Product Change Notice (PCN)

PCN Number: PCN-0451188R-01

Product(s) Affected: *PJ-051A, PJ-051B, PJ-051AH, PJ-051BH*

Description of Change: *Photos of changes included below.*

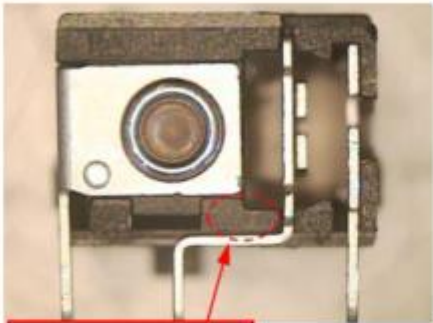
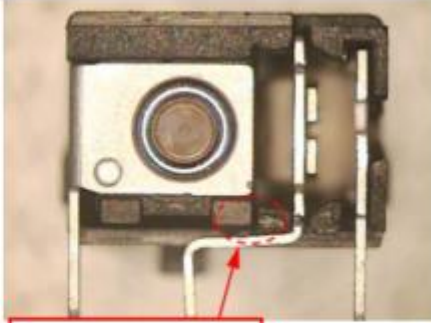
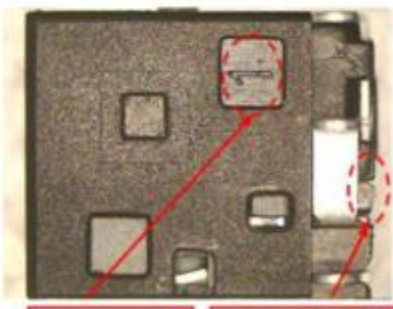
Reason(s) for Change: *The existing molds of PJ-051A, PJ-051B, PJ-051AH, and PJ-051BH are unable to maintain efficient production. To ensure the quality and lead-time of production, a re-development of the mold has been processed. We have taken this opportunity to also optimize the product design to enhance the quality. The new mold will optimize the design, enhance the appearance, the electrical structure while function will remain the same (The comparison photos are available below).*

New version	Current version
Back	 <p>Without gap</p>	 <p>With gap</p>
Bottom	 <p>Smaller mark Without gap</p>	 <p>Bigger mark With gap</p>
